Access Compliance Report

Public Rights-of-Way

Intersection ID: 22096	Main Street: COLONY_RD	Cross Street: CARMEL_CRESCENT_DR	Location: SE
ADA ID: 17F4C4B098B0	Ramp Type: PerpDiag	Initial Pass/Fail: Fail	Overall Compliance: No
Severity Score: 12.5			
Codes/Mitigation Info/Possible Solution		Field Measurements/Component Compliance

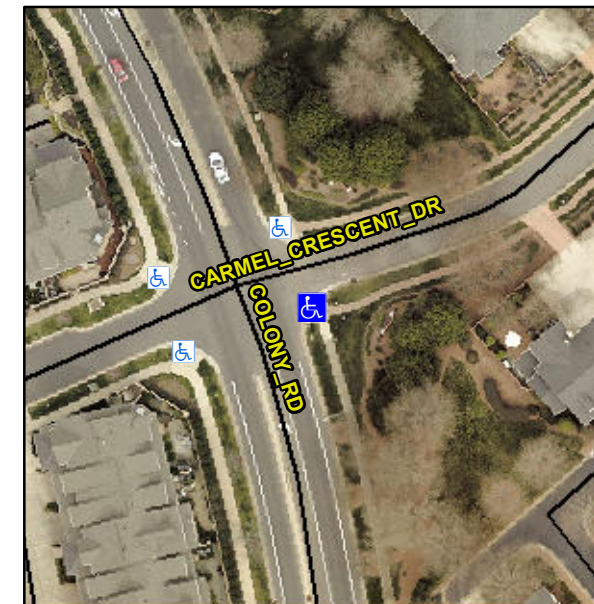
Not Found, R304.5.3

Compliance	Description	Data	Compliance	Description	Data
N/A	Ramp Length (in)	87.0	Yes	Ramp Slope (%)	6.4
Yes	Ramp Width (in)	53.0	No	Ramp XSlope (%)	5.1
N/A	Flare Type LT	N/A	N/A	Flare Type RT	N/A
N/A	Flare Slope LT (%)	N/A	N/A	Flare Slope RT (%)	N/A
N/A	Flare Traversable LT?	N/A	N/A	Flare Traversable RT?	N/A
N/A	Landing Length (in)	N/A	N/A	DWS Provided?	N/A
N/A	Landing Width (in)	N/A	N/A	DWS Contrast?	N/A
N/A	Landing Slope (%)	N/A	N/A	DWS Length (in)	N/A
N/A	Landing X Slope (%)	N/A	N/A	DWS Full Width?	N/A
N/A	Landing Curb? (Y/N)	N/A	N/A	DWS Offset (in)	N/A
N/A	Shared Landing?	N/A			
N/A	Gutter Ponding?	N/A	N/A	Gutter Slope (%)	N/A
N/A	Gutter Lip Ht (in)	N/A	N/A	Gutter X Slope (%)	N/A
N/A	Painted X Walk1?	No	N/A	Painted X Walk2?	No
	X Walk 1 Direction	To NW		X Walk 2 Direction	To SW
N/A	X Walk 1 Width (in)	N/A	N/A	X Walk 2 Width (in)	N/A
	X Walk 1 Slope (%)	3.5		X Walk 2 Slope (%)	2.0
	X Walk 1 X Slope (%)	0.1		X Walk 2 X Slope (%)	1.5

Remove & Replace Curb Ramp With Two New Directional Ramps or Equivalent.
